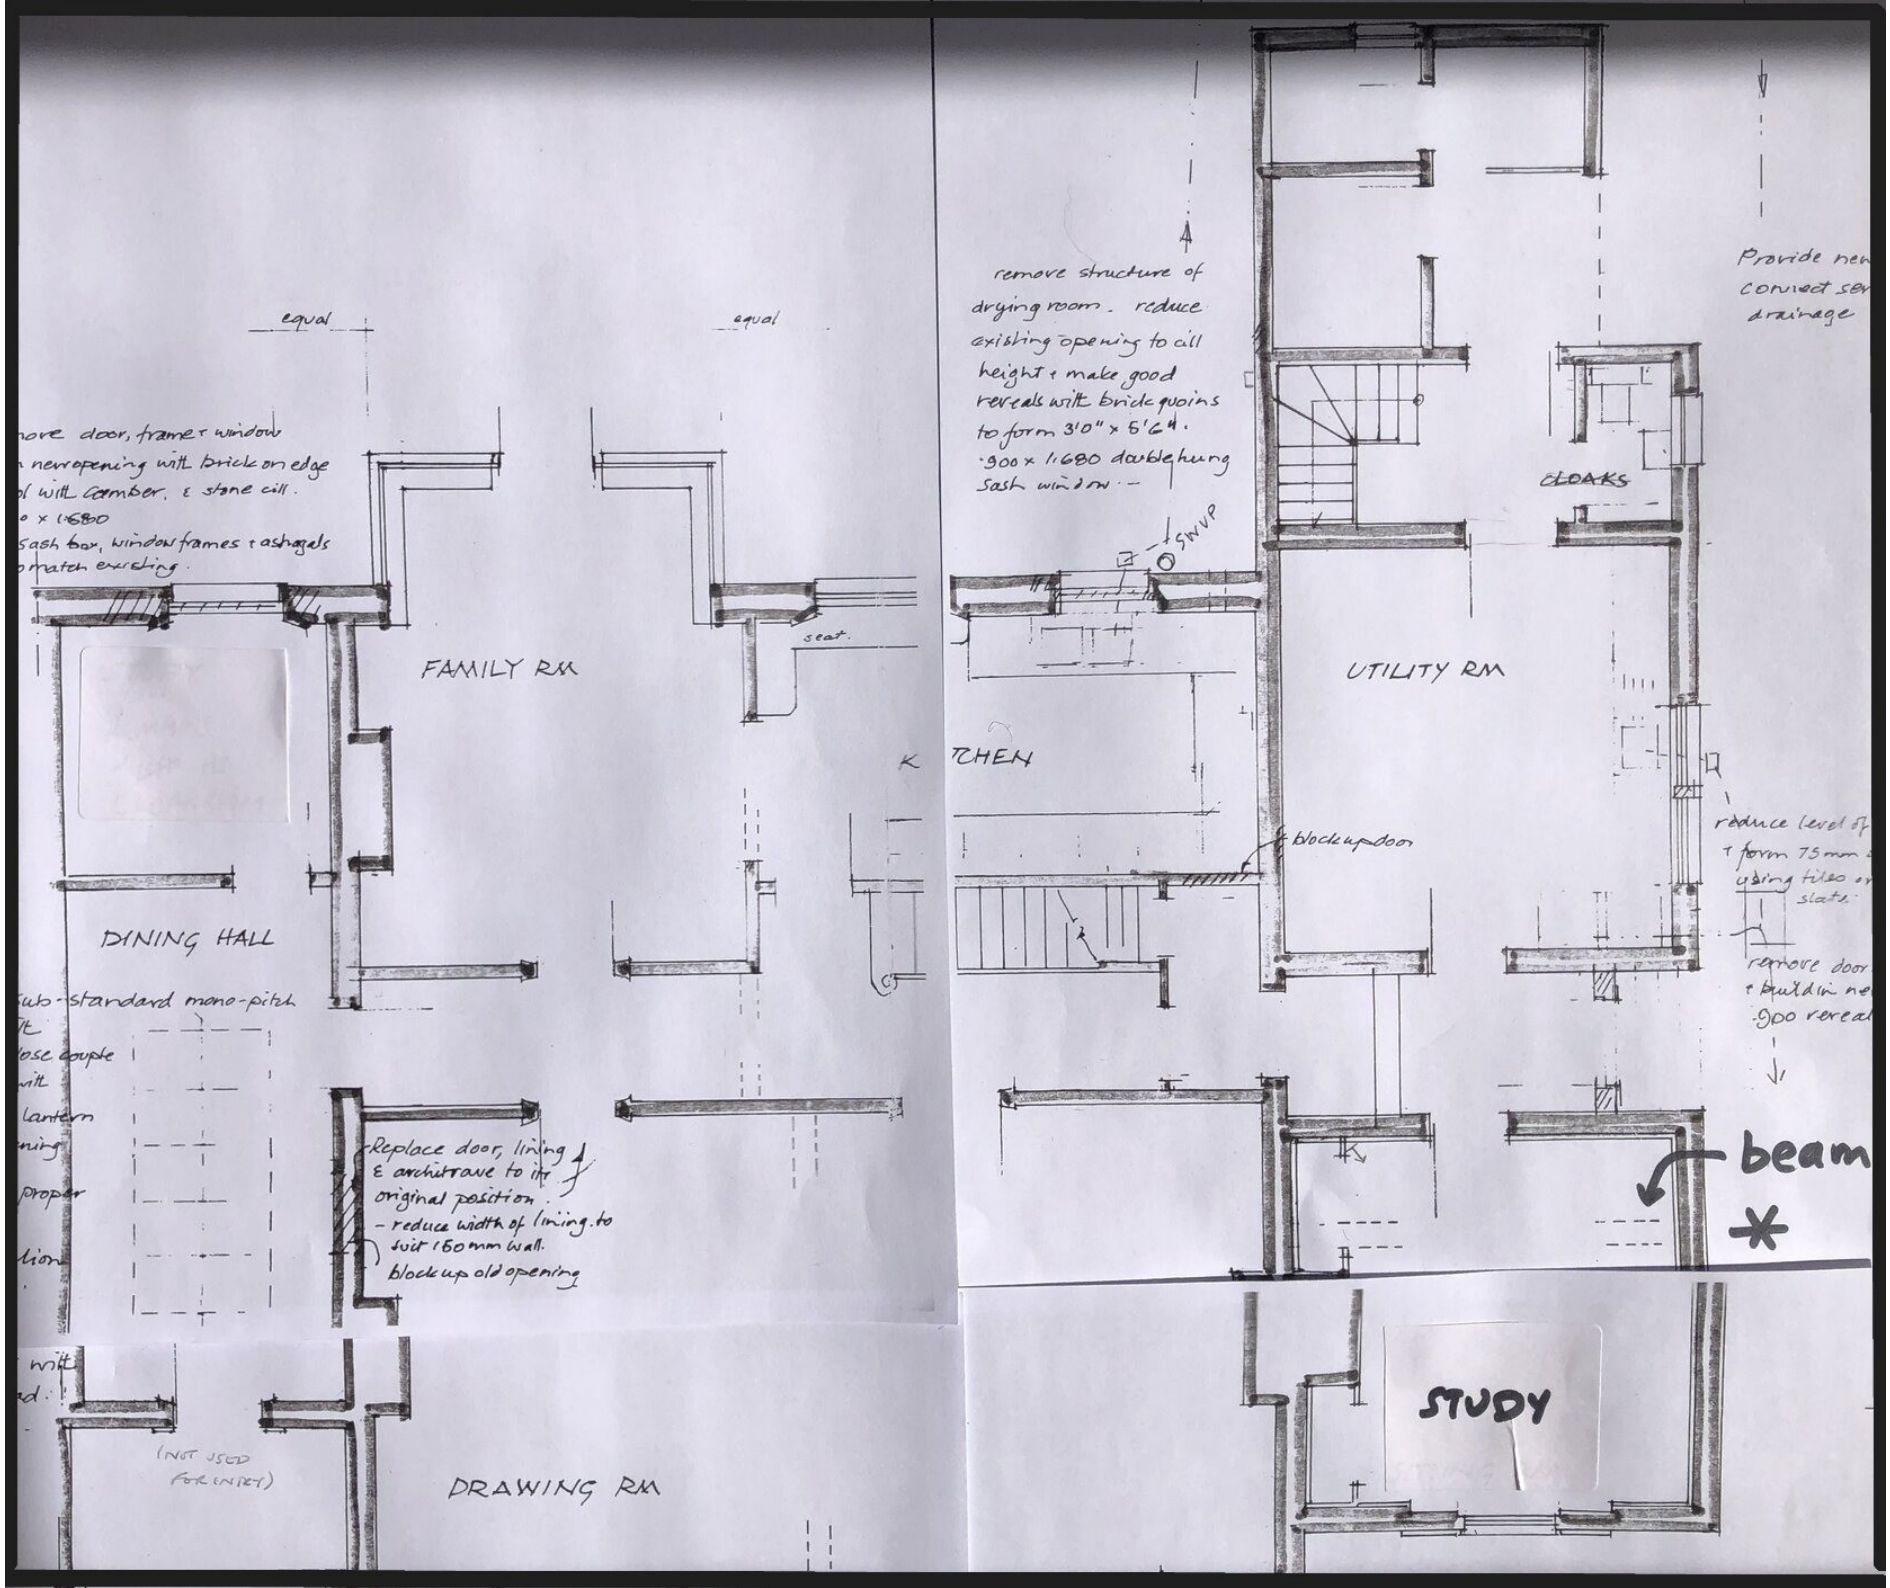
equal
equal
nove door, frame + window
n new opening with brick on edge
l with camber. & stone cill.
o x 1.680
sash box, window frames + ashagals
o match existing.
FAMILY RM
seat.
DINING HALL
sub-standard mono-pitch
lose couple
with
lantern
ning
proper
lion
Replace door, lining & architrave to its original position.
- reduce width of lining to suit 150mm wall.
block up old opening
(NOT USED FOR ENTRY)
DRAWING RM
remove structure of drying room. reduce existing opening to cill height + make good reveals with brick quoins to form 3'0" x 5'6".
.900 x 1.680 double hung sash window.
SWVP
CLOAKS
UTILITY RM
block up door
Provide new
connect ser
drainage
reduce level of
+ form 75mm
using tiles or
slate.
remove door
+ build in ne
.900 reveal
beam
*
STUDY
